Proposed Plan Change 42: Mangaroa and Pinehaven Flood Extents

Hearing: Wednesday 27th, Thursday 28th, Friday 29th September 2017

From: Save Our Hills (Upper Hutt) Incorporated (SOH), C/- Stephen Pattinson, President

1.1 Summary and Conclusion of the Submission by Save Our Hills (Upper Hutt) Inc.

Fig. 7. Map 7 “Pinehaven Stream – Flood Map” From a series of 10 GWRC flood maps for the Pinehaven Stream which resulted from Focus Group meetings facilitated by UHCC and held in Silverstream during April/May 2016. [Status: still current]

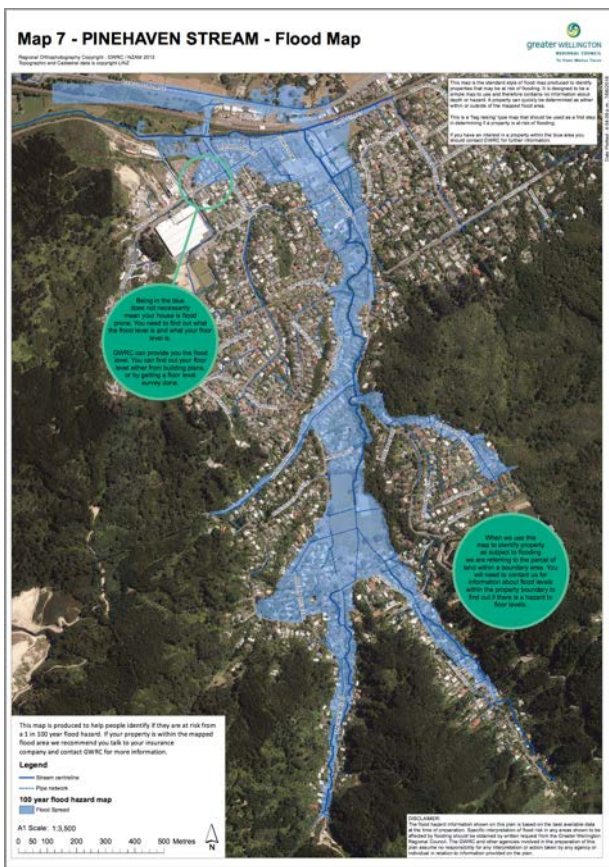
2.2.12 UHCC indicated that Map 7 in a series of 10 GWRC flood maps for the Pinehaven Stream that resulted from the Council facilitated Focus Group meetings in Silverstream in April/May 2016 was the underlying map that informed the UHCC PC42 Flood Hazard Maps (2.2.8 VIII(a) and Fig. 7 below).

2.2.13 The definitive GWRC Pinehaven Stream flood map which informed PC42 UHCC Flood Hazard Maps that were publicly notified on 8th March 2017 is “Pinehaven Stream: Map 0 – Flood Map” (2.2.8 VIII(b) and Fig. 8 below). This was confirmed by Brett Osborne on 8 May (closing day of consultation) after he checked with GWRC, noting however that “GWRC advise ... the flood extent in Field Street does not extend north of the railway line.” (Email 8 May 2017 B. Osborne to S. Pattinson) This was the most recent GWRC Pinehaven Stream flood map on GWRC’s website, available in an 8-page publication titled “Pinehaven Stream: Building a Flood Map” during PC42 consultation.

Fig. 10 – GWRC Pinehaven Stream Floodplain Management Plan, Rev 6, 6 Sept 2016, Vol 2 Maps, available now on GWRC’s website, but not during PC42 consultation. [Status: the fact that it is available on GWRC’s website in Volume 2 companion to Volume 1 FMP suggest it’s still current.]

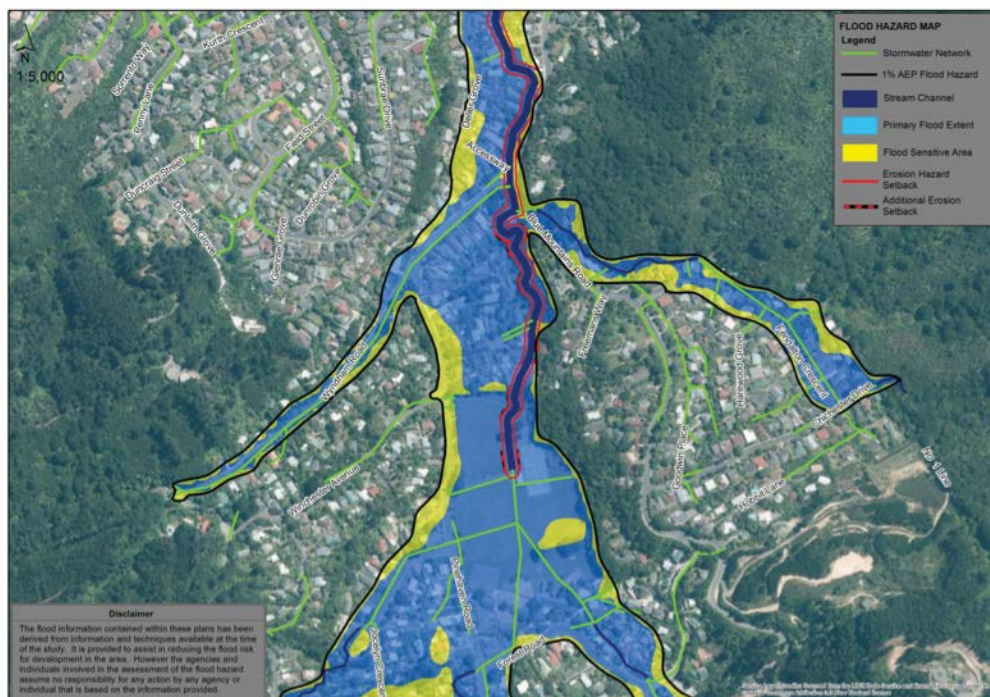
2.2.16 A sample of the style of flood hazard map given in Volume 2 (the flood hazard Pinehaven Reserve) is shown in Fig. 10. These GWRC Pinehaven Stream flood maps are still available on GWRC’s website as at today’s date:

Fig. 11 - GWRC Pinehaven Stream Flood Map Sheet 4 – Pinehaven Reserve (created July 2017, after submissions closed 8th May 2017, and released to submitters 4th September, 3 weeks before hearing)

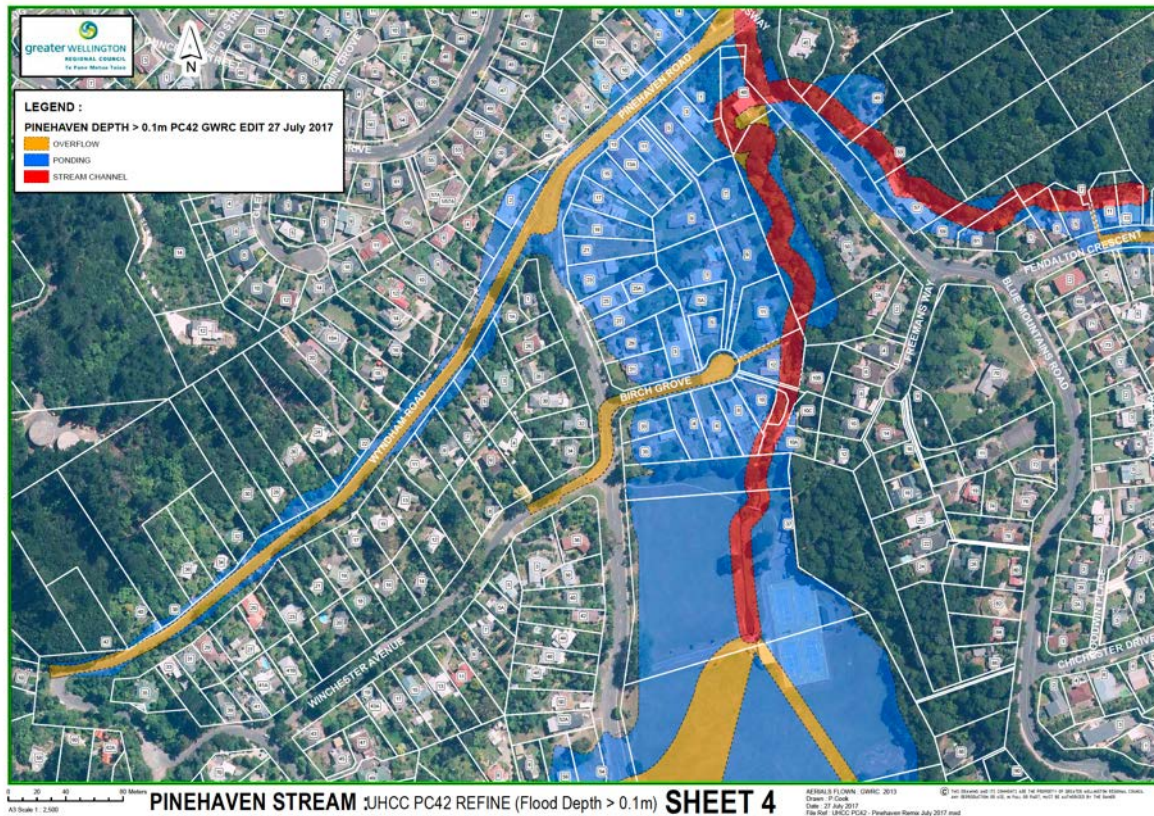
2.2.18 The new GWRC Flood Hazard Extent maps dated July 2017 maps have a new flood hazard colour coding and legend, different from any flood maps the public have seen before for Pinehaven Stream. These new flood maps show:

- a) “Overflow” – coloured yellow
- b) “Ponding” – coloured blue
- c) “Stream Channel” – coloured red

2.2.19 There is no information on these new flood maps (Fig. 11) about depth of flood water or velocity of flow, and no description of the nature or level of flood hazard. GWRC advise that 100mm has been taken off, but there is no explanation about why, how or where. Anyway it doesn't matter, because GWRC also advise that these are not the real flood maps. The real flood maps are still GWRC's original 2010 maps with the 100mm still on them (Figs. 1 & 2 above). After all these versions and changes in GWRC's flood maps for Pinehaven Stream over the last 7 years, GWRC advise that their 2010 maps are still the current maps!

2.2.20 There is no information in the PC42 s42A report explaining how the 100mm has been removed from the flood hazard extents.

2.3.1 Given the above, a new s32 evaluation is required to address the shortfalls identified in all the foregoing, including the appropriateness of the new information issued after the PC42 consultation period in fulfilling the objectives of the proposed plan change. The new s32 needs to identify and evaluate the way the 100mm has been removed from the flood hazard extents.

2.3.2 The new s32 evaluation needs to be notified and the public and previous submitters be given opportunity of new consultation to review and submit on the revised maps and new information that was released 4 September 2017.
